This Carolina Thomas Bus Buzz is a friendly reminder to all North Carolina LEA's to verify you have performed SF249A on all older FS65's with Caterpillar engines.

**Reminder of Issue Communicated Previously  
Per Field Service Campaign SF249A from 2002**

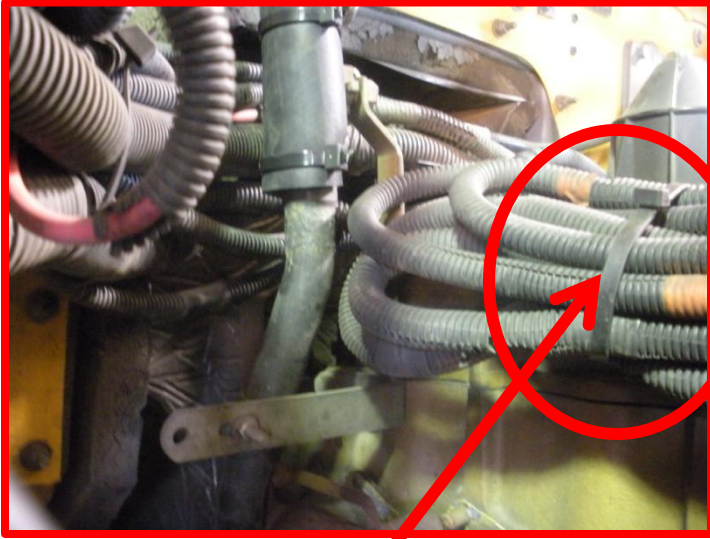
**Improper use of zip ties on looms above exhaust manifold.**

**When inspecting units we are still noticing that some units still have zip ties securing wire looms above the exhaust manifold. Wiring looms above the exhaust manifold should not be secured with zip ties. They should be P-clamped to the valve cover to avoid failure of zip ties due to heat per SF249A. Zip ties this close to the exhaust heat can weaken over time and then allow the wiring to drop down on hot exhaust components. See Photos. A copy of SF249A is posted on our website for your convenience in the Carolina Thomas Bus Buzz section.**

**Proper P-Clamp of wires above exhaust manifold.**
